# Quality Inspection Report

for Central Government  
Employees Welfare  
Housing Organisation (CGEWHO)

by Housing & Urban  
Development Corporation Ltd.,  
Consultancy Wing , Chennai

###### ***Terrace/roof top:***

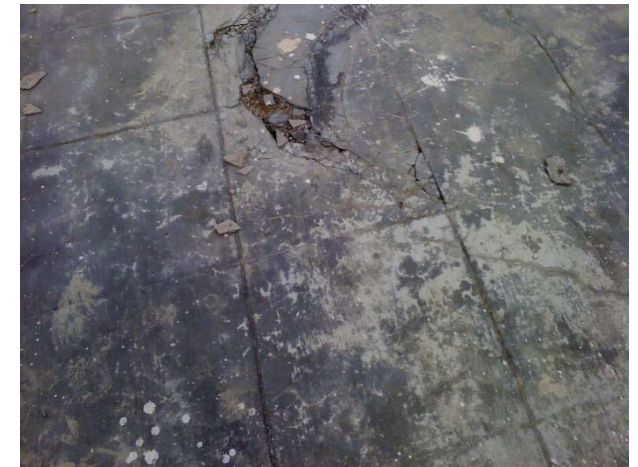
1. Water stagnation on the terrace due to undulations in most places.
2. Weather Proof course damaged and broken on most terraces which have been temporarily covered with sand and bitumen.
3. In certain blocks, expansion/construction joints are not sealed.

4. Construction waste material has been dumped on the terrace of some blocks.
5. Khurra not provided anywhere.
6. Overflow pipes from overhead water tanks are not connected to drain pipes.
7. Height of parapet walls ranges between 68 and 74 centimeters.
